# Access Compliance Report

## Public Rights-of-Way

### (Curb Ramps)

Intersection ID: 3098	Main Street: STEWART_SPRING_LN	Cross Street: WALDEN_RIDGE_DR	Location: S
ADA ID: 9BF070C3C2AE	Ramp Type: BlendTrans2	Initial Pass/Fail: Fail	Overall Compliance: No
Severity Score: 1.25			
Codes/Mitigation Info/Possible Solution		Field Measurements/Component Compliance

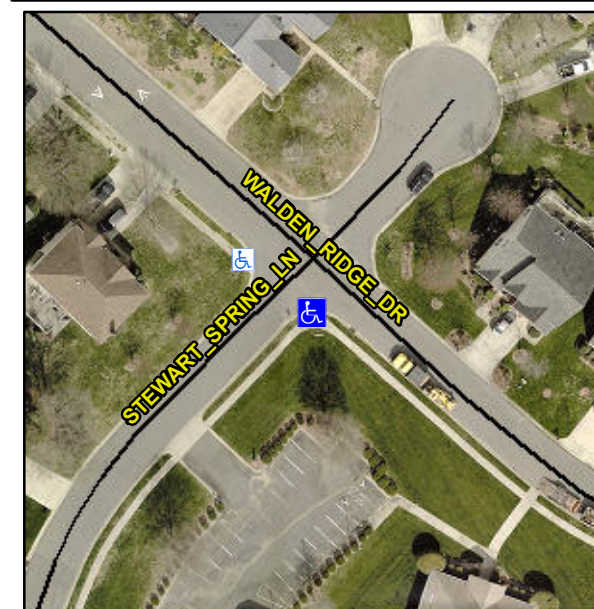
**Not Found, R304.5.3**

Compliance	Description	Data	Compliance	Description	Data
N/A	Ramp Length (in)	94.0	Yes	BlendTrans Slope (%)	2.5
Yes	Ramp Width (in)	48.0	No	BlendTrans XSlope (%)	2.6
N/A	Flare Type LT	N/A	N/A	Flare Type RT	N/A
N/A	Flare Slope LT (%)	N/A	N/A	Flare Slope RT (%)	N/A
N/A	Flare Traversable LT?	N/A	N/A	Flare Traversable RT?	N/A
N/A	Landing Length (in)	N/A	N/A	DWS Provided?	N/A
N/A	Landing Width (in)	N/A	N/A	DWS Contrast?	N/A
N/A	Landing Slope (%)	N/A	N/A	DWS Length (in)	N/A
N/A	Landing X Slope (%)	N/A	N/A	DWS Full Width?	N/A
N/A	Landing Curb? (Y/N)	N/A	N/A	DWS Offset (in)	N/A
N/A	Shared Landing?	N/A			
N/A	Gutter Ponding?	N/A	N/A	Gutter Slope (%)	N/A
N/A	Gutter Lip Ht (in)	N/A	N/A	Gutter X Slope (%)	N/A
N/A	Painted X Walk1?	No	N/A	Painted X Walk2?	N/A
	X Walk 1 Direction	To NW		X Walk 2 Direction	N/A
	X Walk 1 Width (in)	N/A		X Walk 2 Width (in)	N/A
	X Walk 1 Slope (%)	3.4		X Walk 2 Slope (%)	N/A
	X Walk 1 X Slope (%)	4.1		X Walk 2 X Slope (%)	N/A

N/A	Ramp inside XWalk1?	N/A	N/A	Ramp inside XWalk2?	N/A
	Road Slope (%)	4.1		Clear Space?	N/A
	Road X Slope (%)	3.4	N/A	Clear Space to XWalk (in)	N/A
N/A	Any Obstructions?	N/A	N/A	Storm Grate/Utility Hazard?	N/A
	Obstruction Type			Storm Grate/Utility Type	
		N/A			N/A
			Yes	Surface Condition? (G/P)	Good
			No	Curb Slope (%)	10.2

**Remove & Replace Curb Ramp With Two New Directional Ramps or Equivalent.**
